ARCHITECTURAL ACCESS BOARD - HEARING PACKET

Name **New England Sports Center**
Address **121 Donald Lynch Blvd.**
City **Marlborough, MA 01752**

Docket # C24 - 002

New England Sport Center Resolution Plan And Actions Taken In Response To Architectural Access Board Site Visit Report, Notice Docket Number C24-002

NESC Accessible Seating, Rinks 1 Through 8

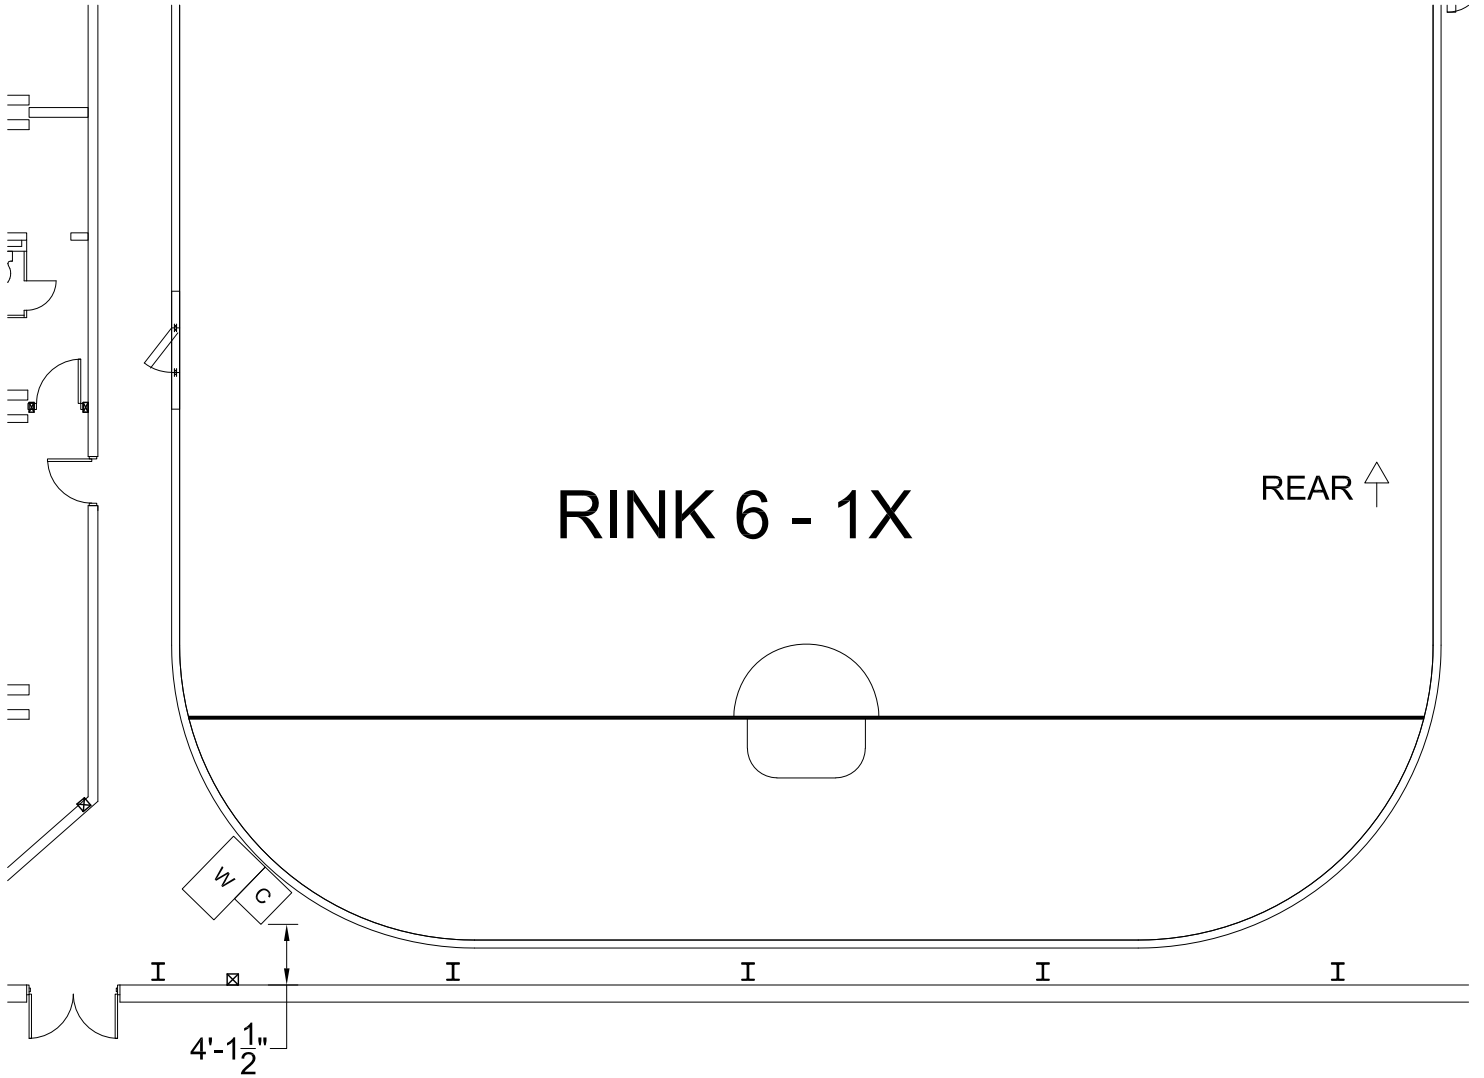
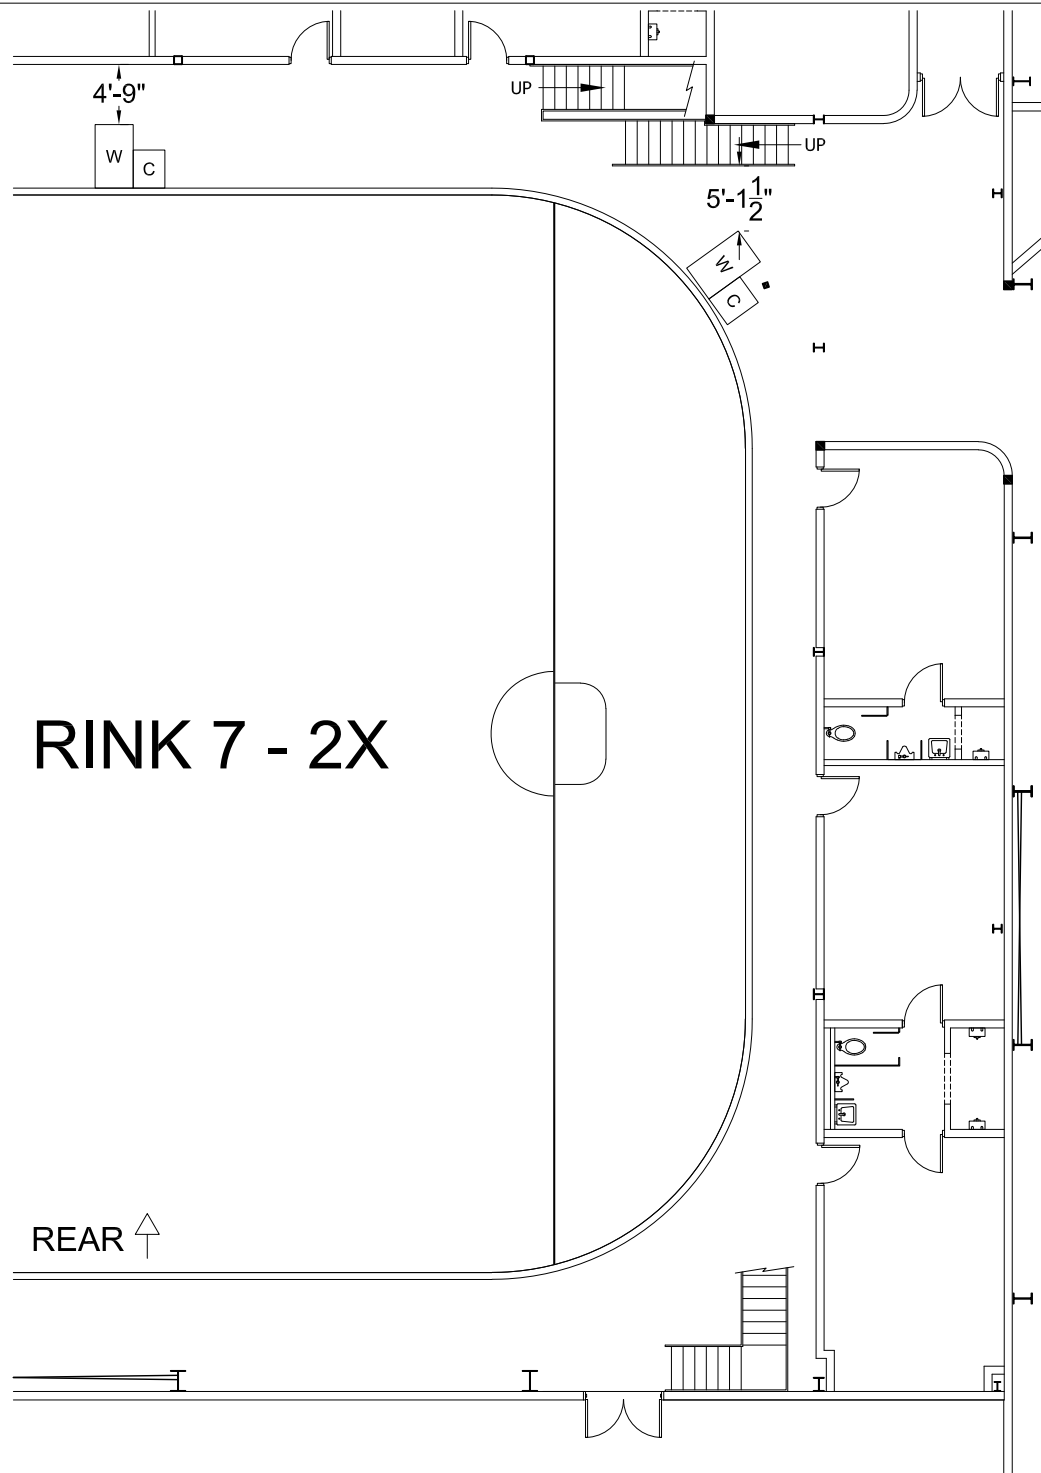
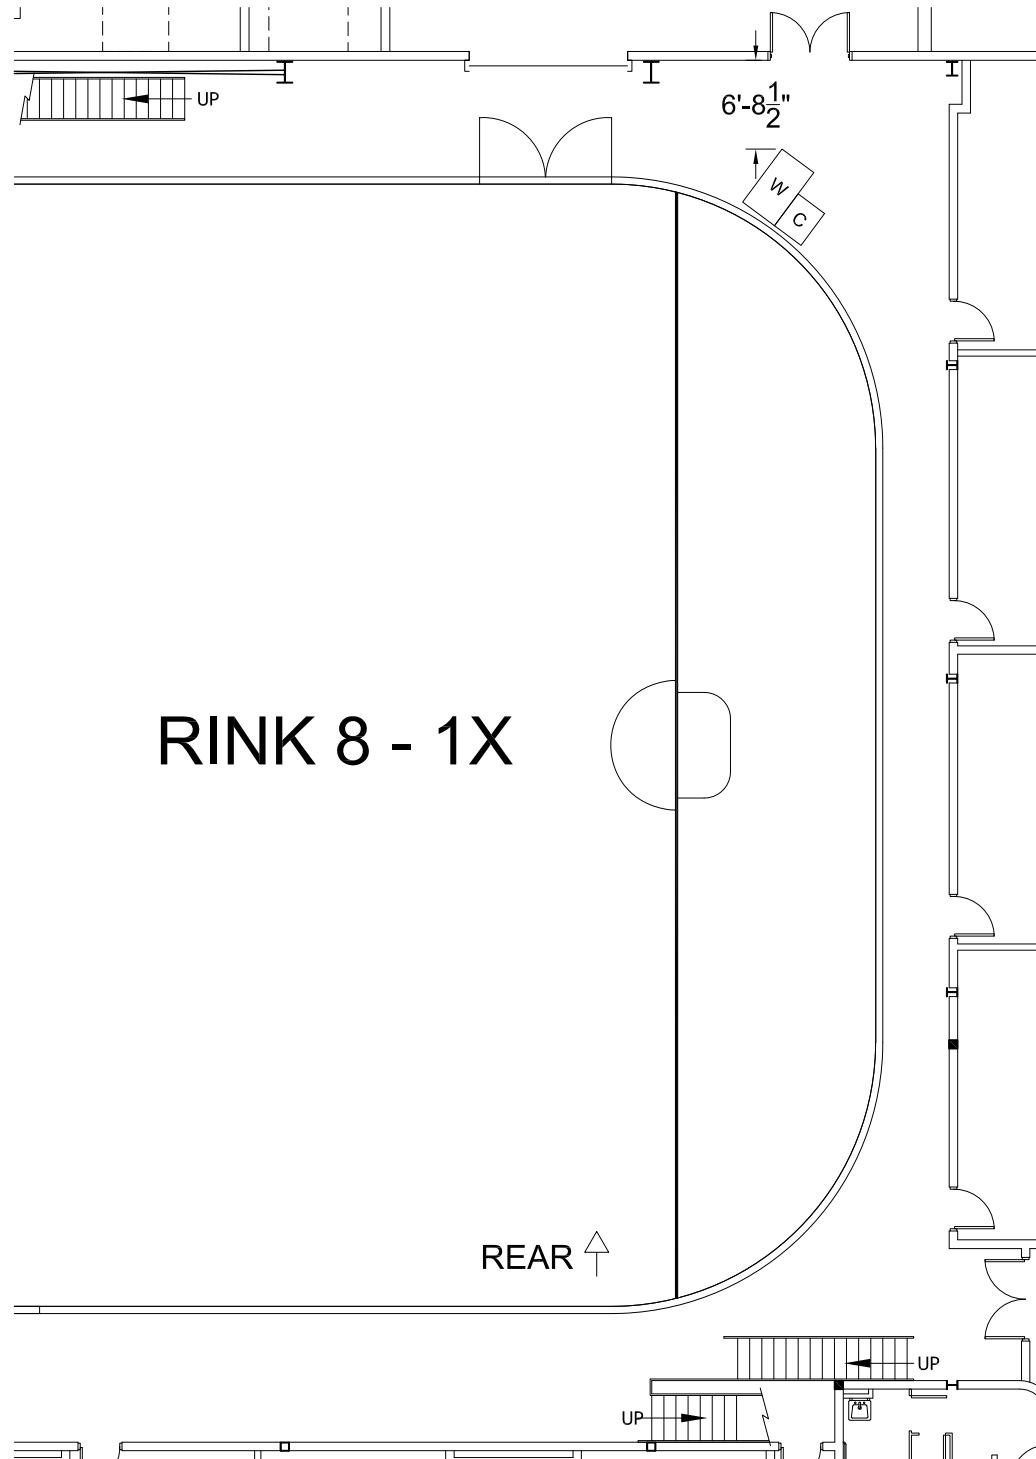
Item	Site Visit Report Paragraph	Complaint	NESC Response And Action Taken	521 CMR Compliance Status
1	2	Rink 1: Stairs throughout spectator seating areas were noted as having uniform treads and risers but were missing handrails.	We understand that there is a possibility that this code requirement will be deleted. Please advise as to whether we should request a waiver or install handrails.	Please Advise
2	2, 7, 8,	Rinks 1 Thorough 8: Lacked required number of accessible seats per 521 CMR 14.2.	Attachment B presents our plan for providing accessible seating in Rinks 1 through 8 per 521 CMR 14.2.	Please Advise
3	2, 6	Rink 1, Main Stairs, Rink 5: Stairs missing the required 12-inch extensions.	Attachment C presents the engineering drawings for adding the 12" railing extensions. Please Advise. .	Please Advise
4	3, 7, 9, 10, 11, 13, 14, 17, 18, 19	Door Opening Force: Per 521 CMR 26.8. I, Requires 5lbs maximum opening force For interior doors . Some doors exceeded the 5lbs. Maximum force requirement.	We have adjusted all doors in NESC have to have a maximum opening force of 5lbs.	Submitted for Approval

Attachment C
Engineering Drawings For Stair Railing Extensions

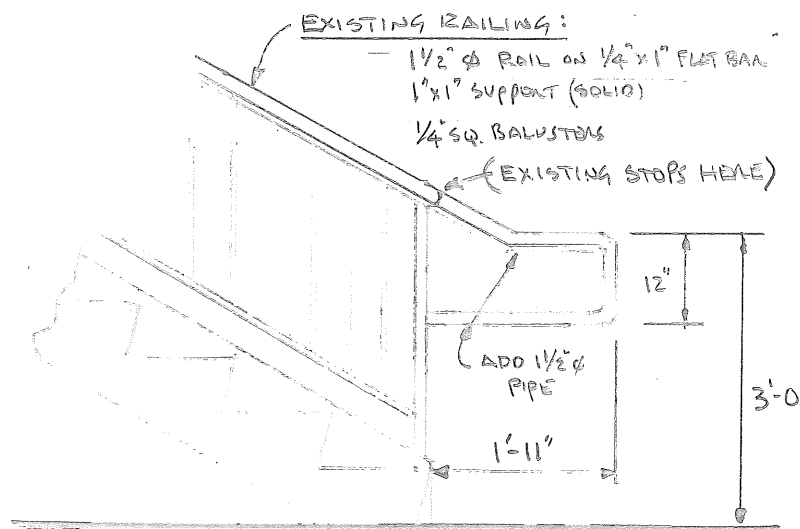
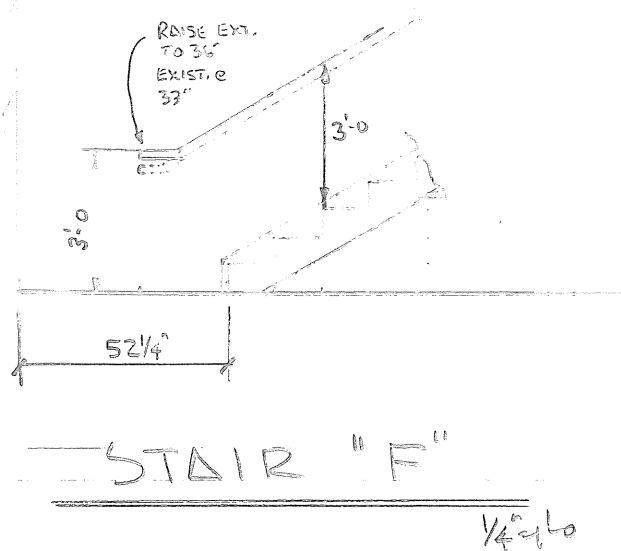
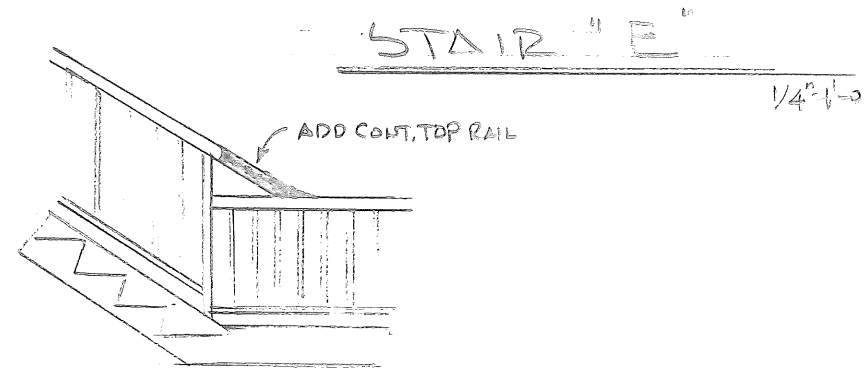
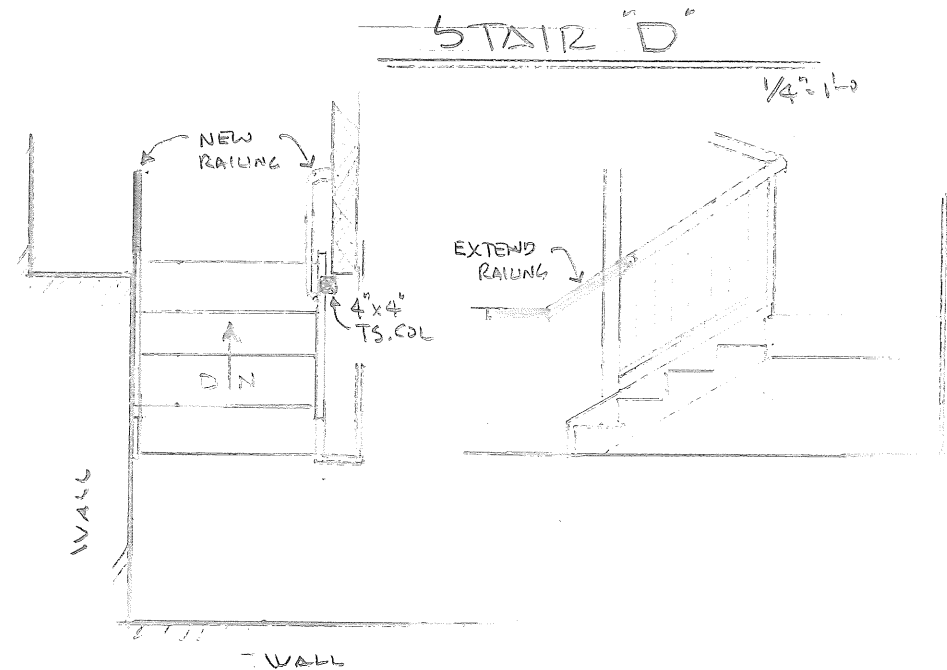
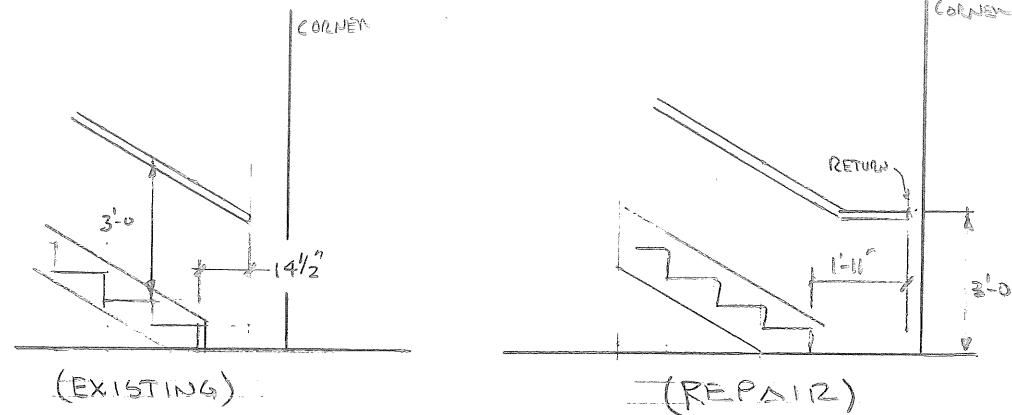
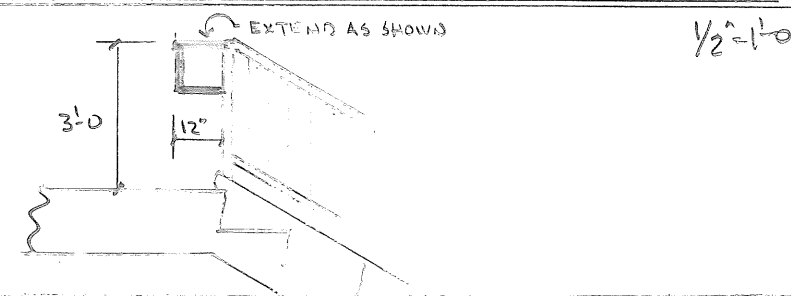
7	6	Main Stairs: Stair two had interrupted handrails.	The repair to Stair Two to be make it compliant with 521 CMR 27.4.1 requiring continuous handrails is illustrated in Attachment F . Please advise	Please Advise
8	7	Rink 4: Ground floor area was noted as having a path of travel which measured at 34 inches wide, 2 inches less than the 36 inches required in 521 CMR 20.3	We have closed this path to the public as shown in Attachment G.	Submitted for Approval
9	9	Rink 5: Stairs(from ground to viewing platform) had a set of stairs within non-uniform treads and risers.	The stairs with non-uniform treads and risers have been repaired to have uniform risers, all within 3/8 inch of each other as shown in Attachment H. We would like to request a waiver on the non-uniform treads, which measure 12 inches on one end and 13.5 inches on the other end of each tread. Please advise.	Please Advise
10	10	Common Viewing Area Between Rinks 5 and 7: Floor area on swing side of this door was measured as having a running slope of 3.6%.. Within this viewing area, non-compliant running slopes varying from 2.3% to 4.2% were measured.	As shown in Engineering Drawing A-3 in Attachment I, the sloped mezzanine floor area between Rinks 5 and 7 cited is 74 feet, 7 inches in length with a 2 feet, 5 5/8 inches (29 5/8 inches) change in elevation. The slope is 0.033, less than the 0.05 minimum slope to be a ramp under 521 CMR 24.	Submitted for Approval

ALL STAIR RAILINGS ARE TO BE
CORRECTED AS SHOWN AT ALL RINKS

Attachment D: NESC Arcade Transaction Counter Removed

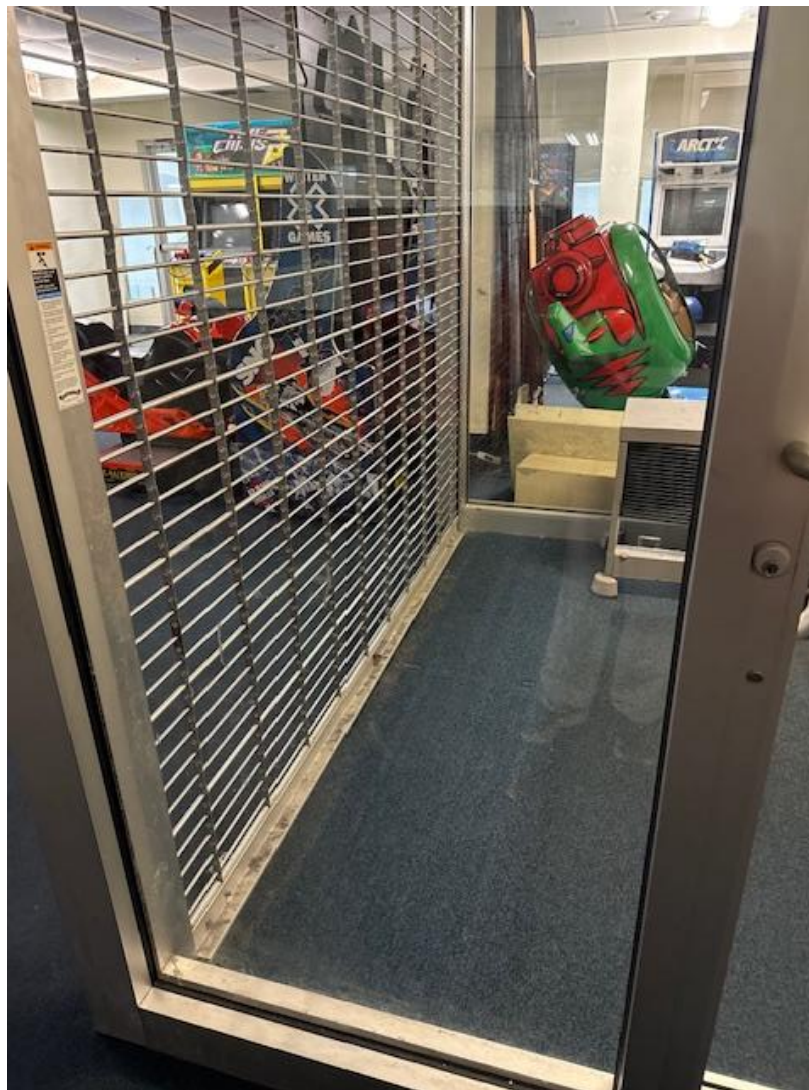
5	4	Arcade Area: It was noted that the height of the transaction counter for game prizes was 38 inches, while the maximum allowable is 36 inches above the finished floor (521 CMR 7.2.2b).	The 38 inch arcade transaction counter is no longer in use. We removed it from the arcade area as shown in Attachment D.	Submitted for Approval
6	5, 12	Mezzanine Common Viewing And Dining Areas: Tables were measured as meeting the 27-inch knee clearance requirements per 521 CMR 35.5, but not the 19-inch clear floor space per 521 CMR 35.4 and 5% of all seating must comply. If compliant tables were located in the adjacent dining area, these could be moved to meet distribution require ments.	We have inventoried the tables in NESC. Seven (7) of the 76 tables at NESC are compliant with the 19-inch clear space requirement, This is three (3) more than the four (4) compliant tables needed to meet the 5% requirement of 521 CMR 35.4. These compliant tables have been identified as handicap compliant and distributed uniformly among the 76 tables as shown in Attachment E.	Submitted for Approval

Attachment K
Accessible Bathroom Modifications Drawing

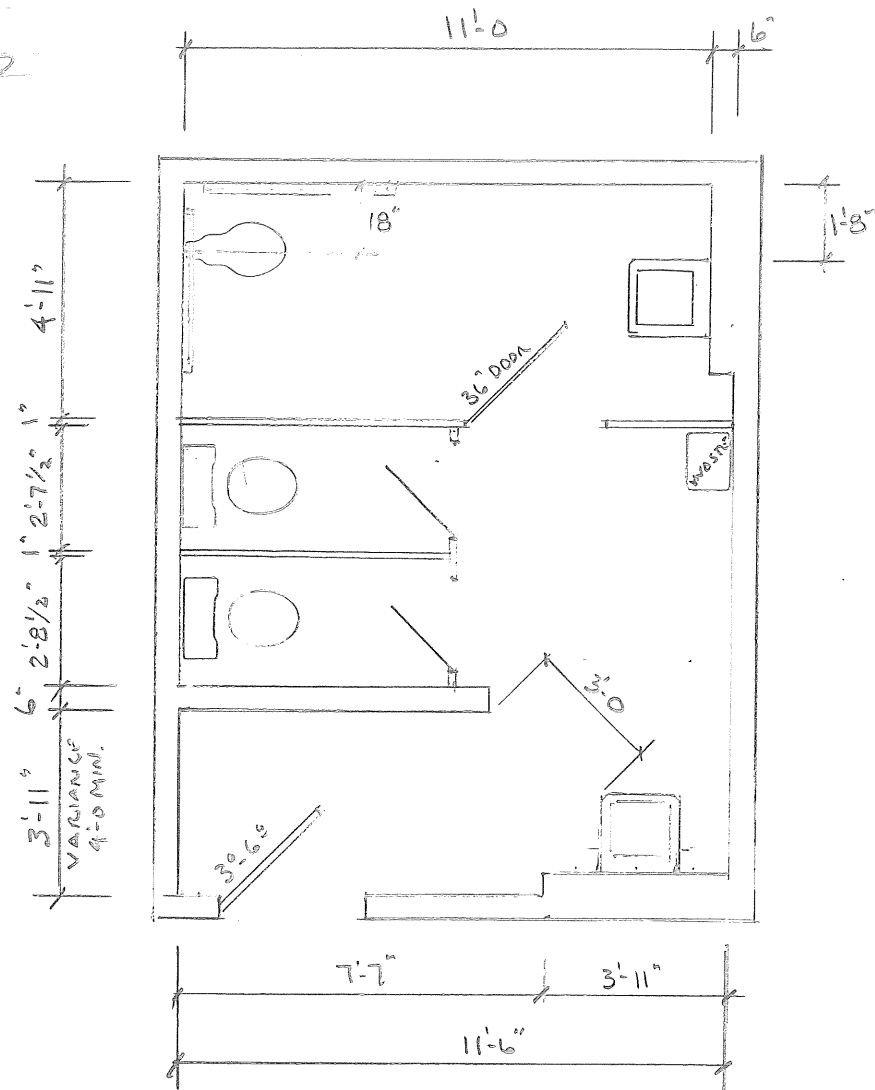
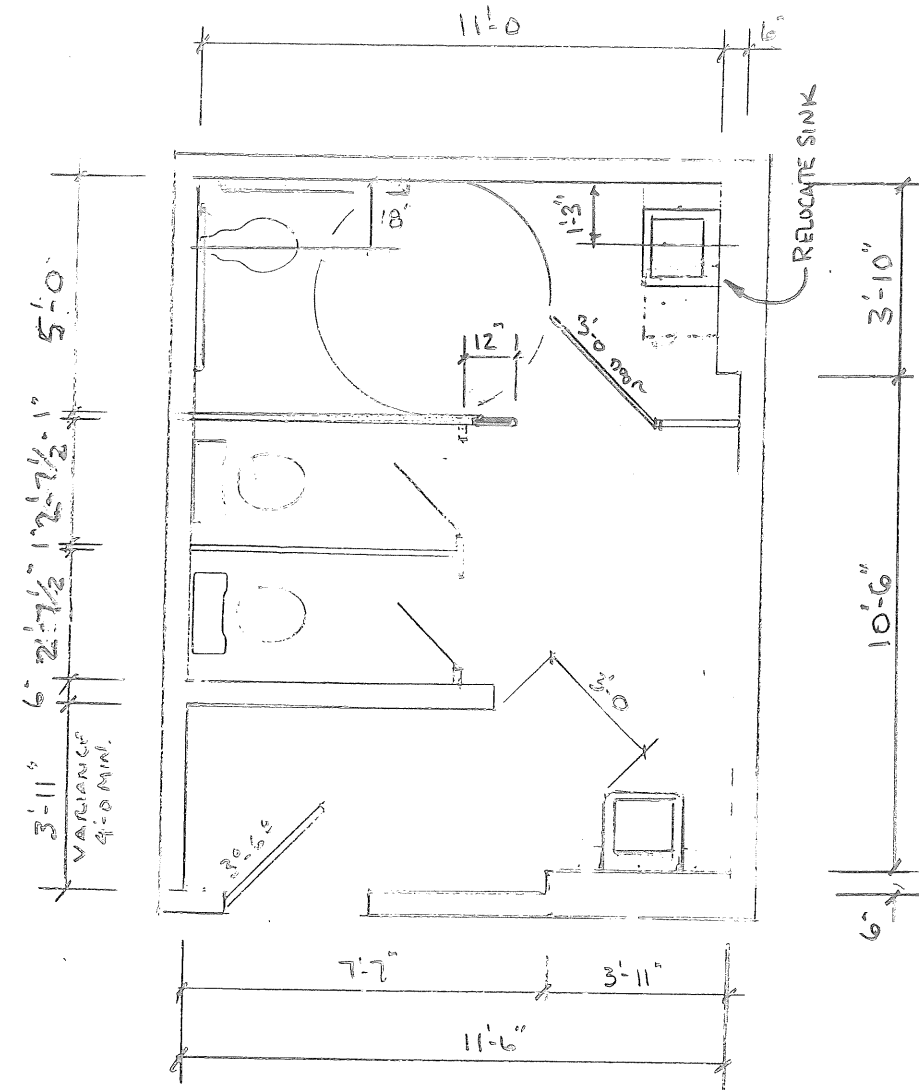
11	12	Common Dining Area: Did not have requisite clear space as per 521 CMR 35.4.	The common dining area have been re-arranged to have 36" clearance among tables and chairs in compliance with 521 CMR 35.4 I.	Submitted for Approval
12	13, 14, 17,18	Second floor (mezzanine) Men's and Women's Bathrooms: Accessible toilet stall doors lacked the required handle on the pull side.	Pull handles have been installed on both sides of the accessible toilet stall doors, shown In Attachment J. In addition, we are implementing the changes shown in Attachment K, Engineering Drawing A-2 recommended by our engineer to be fully compliant with 521 CMR 30	Submitted for Approval
13	16	Elevator Certificate: It was noted that the elevator inspection certificate was due to expire within a week of the site visit (see photo #14). NESC GM Jason Silbor stated that an inspection was scheduled for that week.	The Shindler Elevator Corporation certification is valid through September 30, 2026. See Attachment L	Submitted for Approval
